09-AFC-6

**Subject: Plots Depicting GenTie Clearance from 3 Degree Approach Glide Slope and FAA Part 77 Horizontal Surface on Approach End of Runway 08 at the Blythe Airport  
DOCKET NO. (09-AFC-6)**

To	File: Solar Millennium 60139695 Task 6300	Page 1
CC	Carl Lindner, Mark Luttrell, Arrie Bachrach	
Subject	Plots Depicting GenTie Clearance from 3 degree Approach Glide Slope and FAA Part 77 Horizontal Surface on Approach End of Runway 08 at the Blythe Airport	
From	Howard Balentine 	
Date	June 15, 2010

**Figure 1  
 Topography**

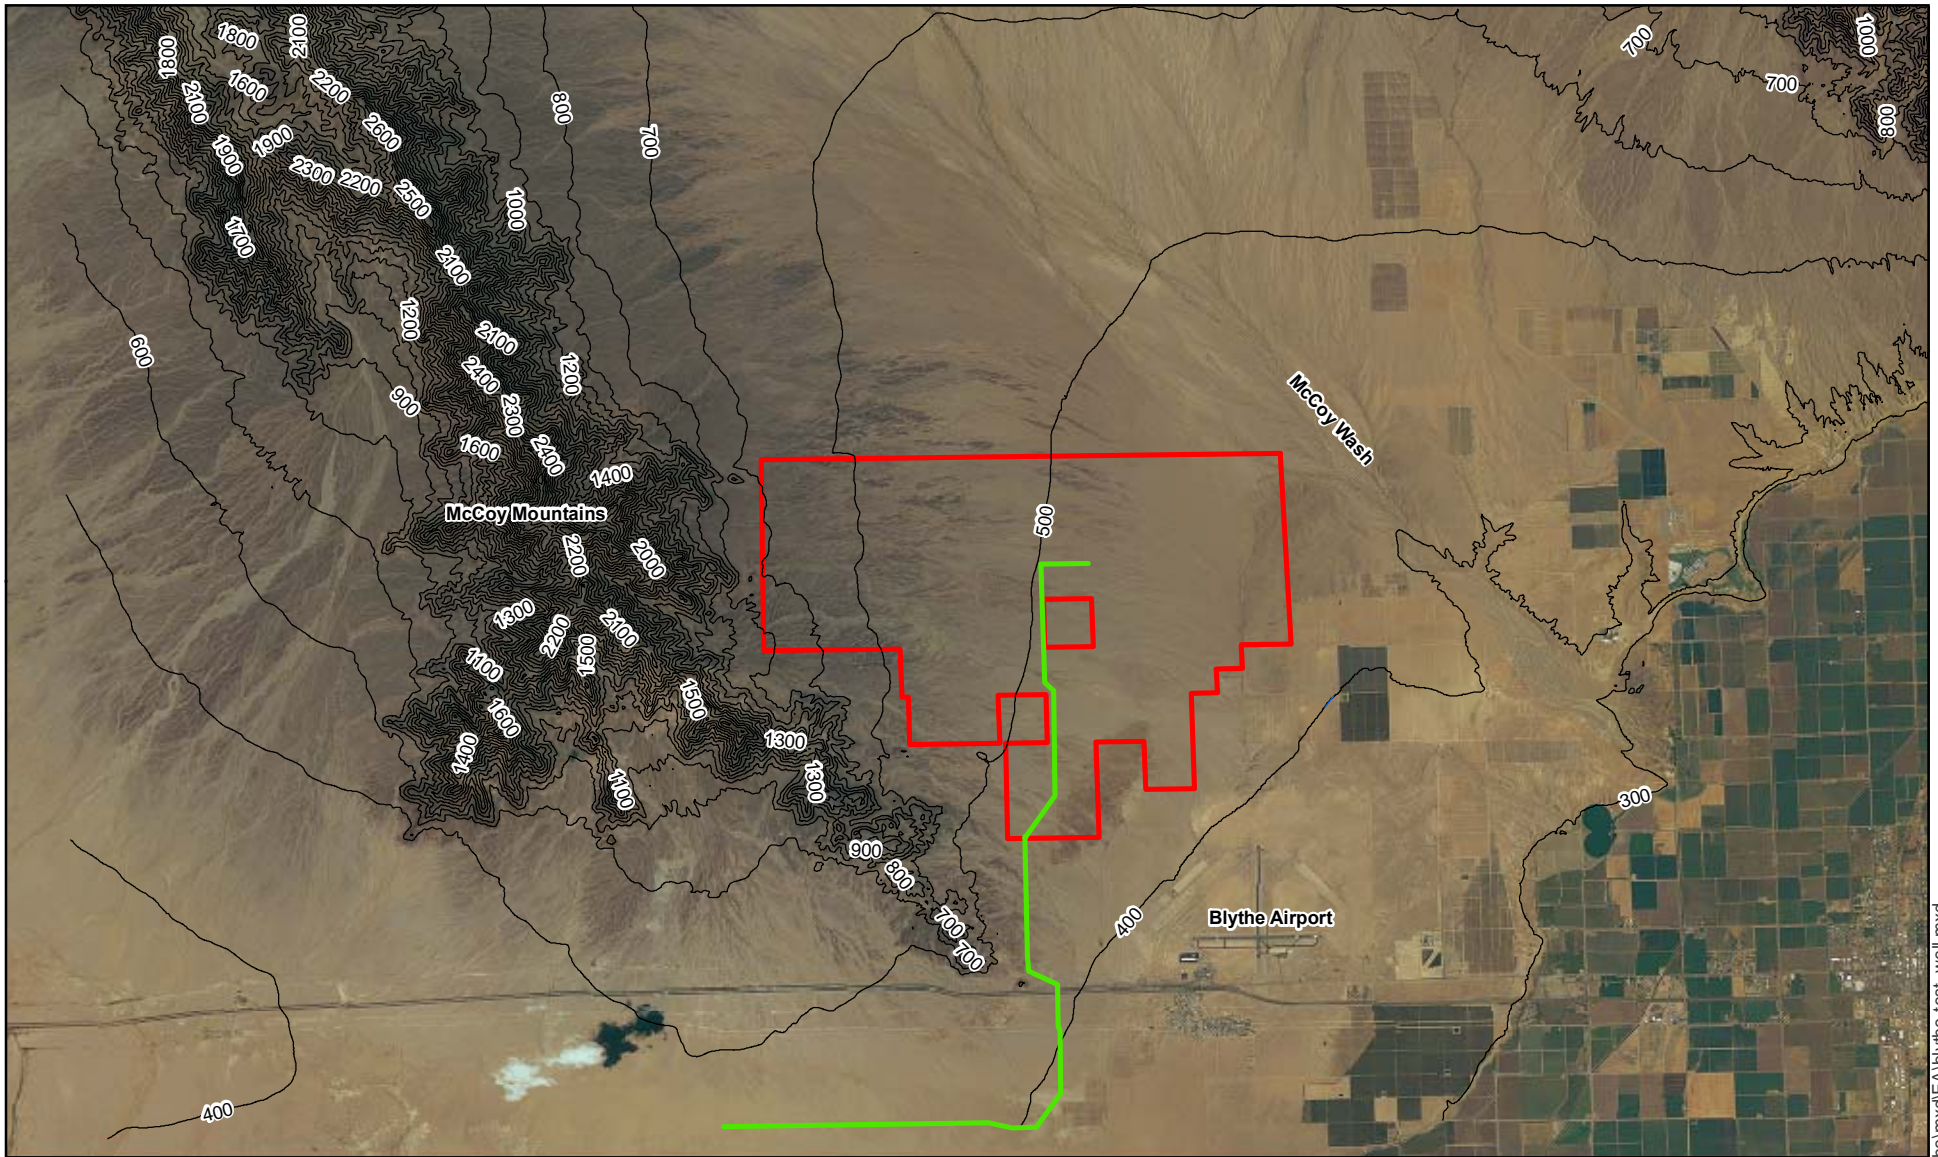
Figure 1 presents a horizontal plan view the Blythe Airport, the BSEP project site and GenTie Route, and the McCoy Mountains. From Figure 1, it is apparent that the proposed GenTie route is already nestled into the rising slope of the McCoy Mountains.

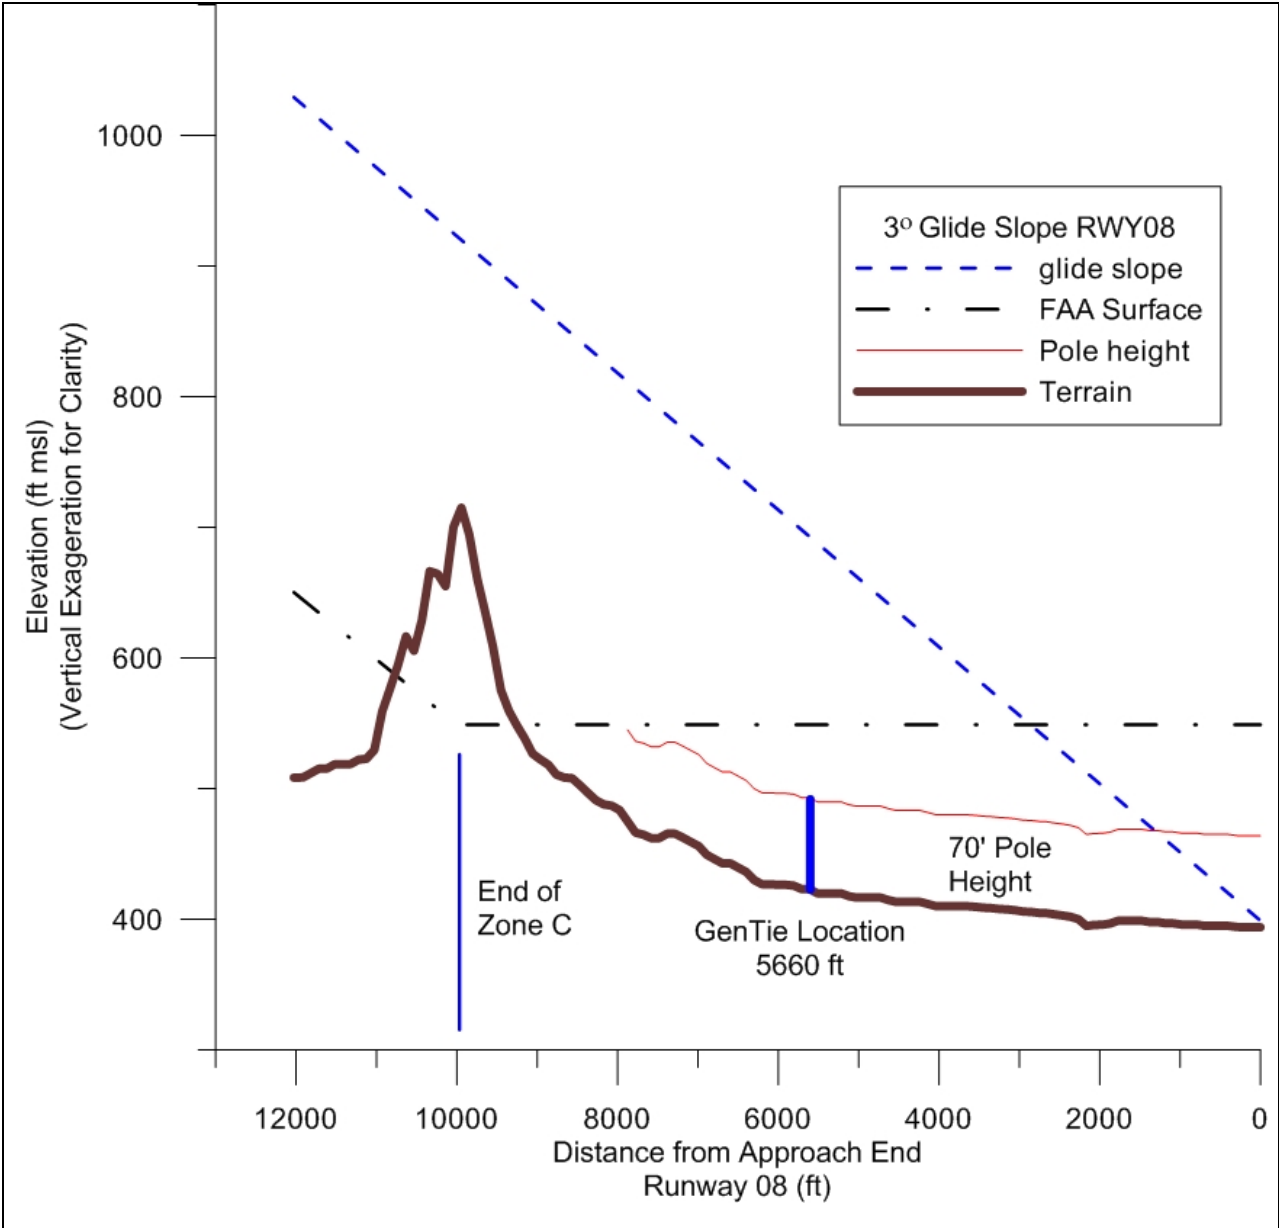
Excellent depiction of the GenTie issue. I concur that the GenTie is now optimally positioned. Looking at Chart 1 (the 4-variable graph), it shows the GenTie position (blue bar) properly "nestled" against the ridgeline, that is, moving it any further west would reduce its margin from the FAR 77 flat line. I don't think the 3 deg (landing approach) glideslope is much of a factor. The more prevalent factor, in my opinion, is maximizing the available climb-out angle for aircraft on departure, which would likely be more restrictive. I think the GenTie is best located exactly where you have it depicted. A good mitigation would be to have visibility balls located on the lines, as Solar Millenium has already volunteered to do.

Figure 2 present an West to East Vertical Slice from the McCoy Mountains to the approach end of Runway 08. This plot presents four separate surfaces: terrain heights, the height of the FAA Part 77 Horizontal Surface, the 3-degree glide slope, and a surface 70 ft above the terrain representing the height of any GenTie poles that will be located in Airport Compatibility Zone C. Plot demonstrates the optimal siting of the GenTie route through Compatibility Zone C west of Runway 08/26. The proposed location of the GenTie line through Zone C is close to maximizing the separation between pole height and the glide slope while at the same time maximizing the separation between the pole height and the Horizontal Surface. Moving the GenTie route will increase the separation from the glide slope but will result in a reduction in clearance underneath the Horizontal surface. At

Figure 3. West to East Horizontal Slice Depicting the Clearance between the Top of the GenTie Poles in Compatibility Zone C and a 3 Degree Approach Glide Slope for Runway 08 at Blythe Municipal Airport. The Plot Begins just West of the McCoy Mountains and ends at the Start of Runway 08.

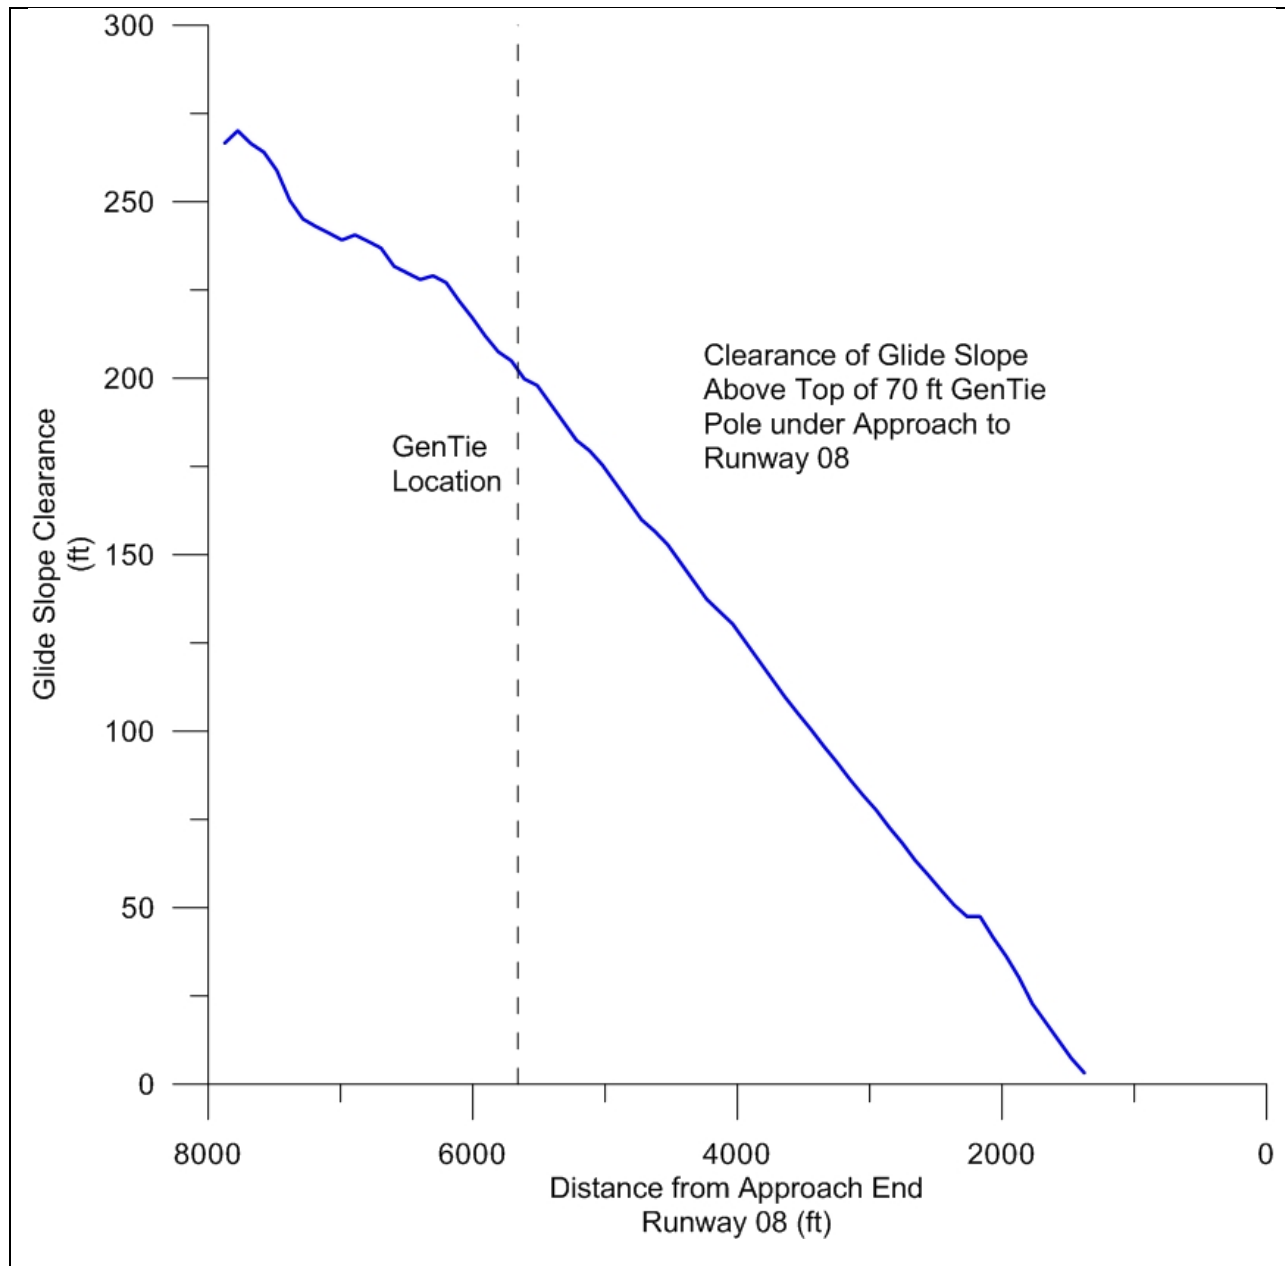
At the Riverside County Airport Land Use Commission meeting on June 10, the Commission requested additional graphics depicting the clearance between the top of the GenTie poles in Compatibility Zone C and the approach 3-degree glide slope for Runway 08. An aircraft approaching Runway 08 will overfly the GenTie line in Zone C and the question posed is what would be the vertical clearance between the top of the GenTie poles and the approach slope if the GenTie line were to be move further west. This discussion occurred after the GenTie route had been previously moved to the west to avoid crossing Compatibility Zones B1.

Figure 3 present the clearance distance between the 70-ft pole height above terrain and the 3-degree glide slope for the West to East Vertical Slice presented in Figure 2. There is not much benefit in moving the GenTie line west. You get an increase in glide slope clearance of about 25 ft increase over the existing GenTie location clearance of approximately 200 ft (13% increase) by moving the GenTie line 1,000 ft west from the current location. You get an approximate 50 ft clearance benefit (25%) over the existing location by moving the line 2,000 ft west but the top of the poles would then be less than 15 ft below the FAA Part 77 Horizontal Surface and you are getting into much steeper terrain that would cause construction difficulties. Beyond about 2,000 ft west, there is essentially no benefit and the pole height would be at or above the FAA Part 77 Horizontal Surface.

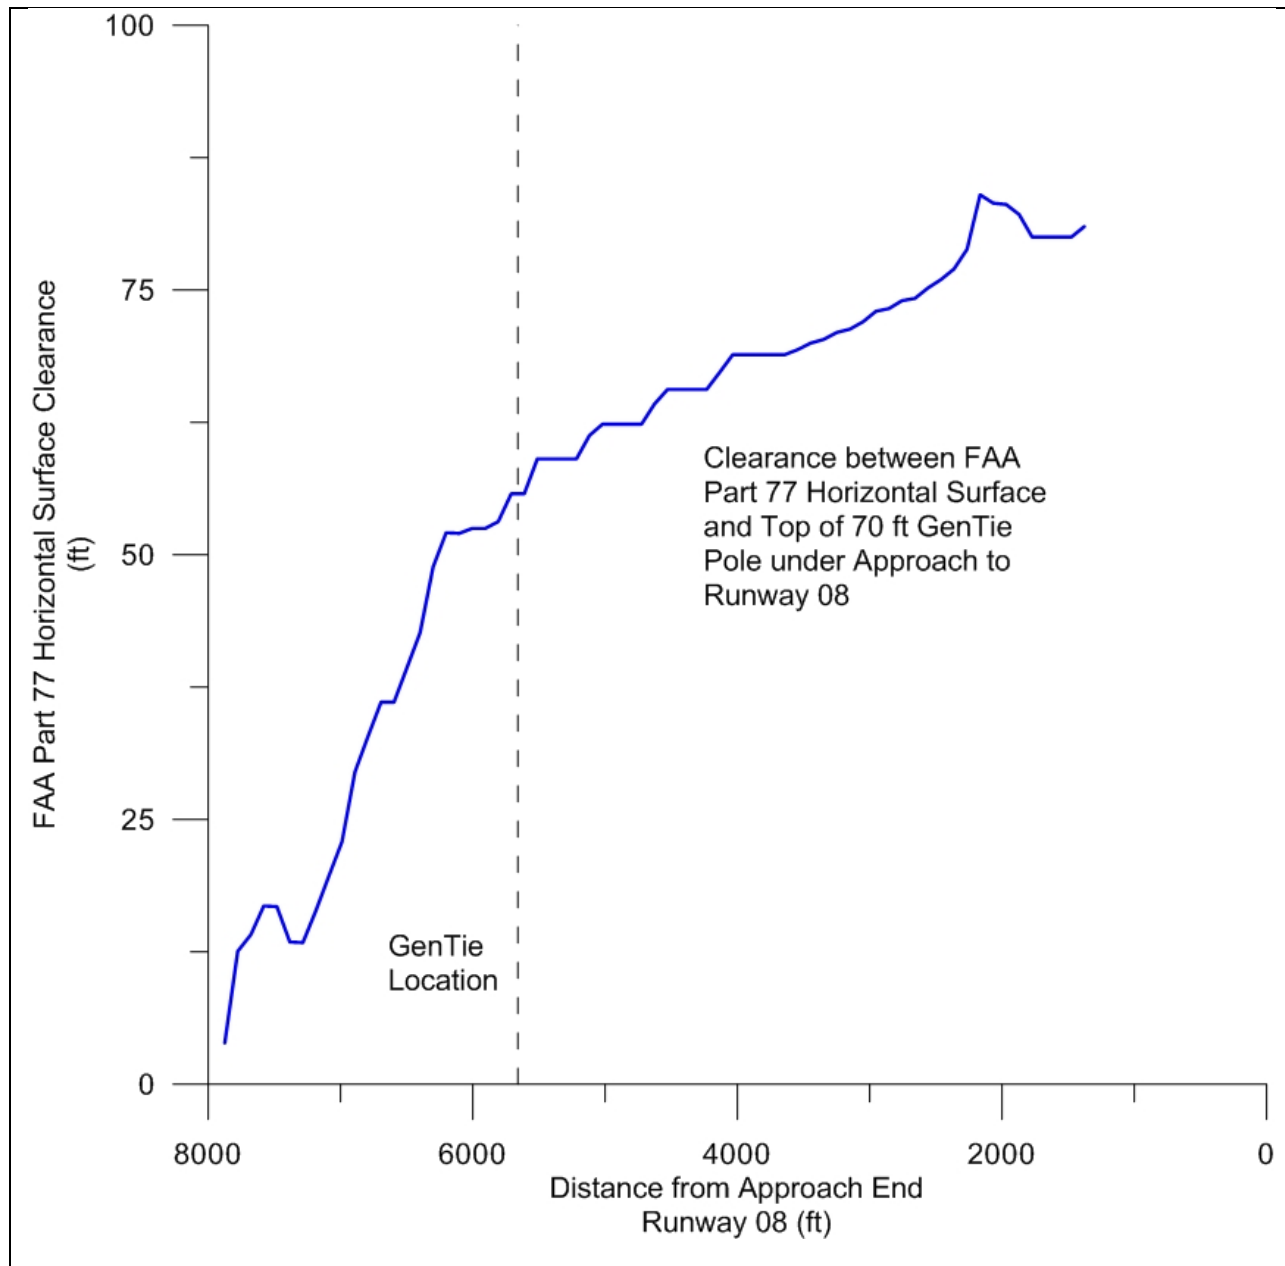
Figure 4 present the clearance distance between the 70-ft pole height above terrain and the FAA Part 77 Horizontal Surface for the West to East Vertical Slice presented in Figure 2. As you move the GenTie line west in Zone C, the horizontal surface remains fixed relative to the airport elevation but terrain is rising underneath it. There is only modest amount of westward movement possible in the GenTie line (~500 ft or less) until there is a large decline in clearance as the terrain begins to rise steeply.

There is very marginal increase in the margin of safety produced by moving the GenTie line west approximately 500 ft. You get an increase in glide slope clearance of about 25 ft increase over the existing GenTie location but you get a decrease in clearance under the Horizontal Surface by approximately 15 ft (approximately 23% decrease). Moving the GenTie line more than 2,000 ft results in no benefit as the pole height would be at or above the FAA Part 77 Horizontal Surface.
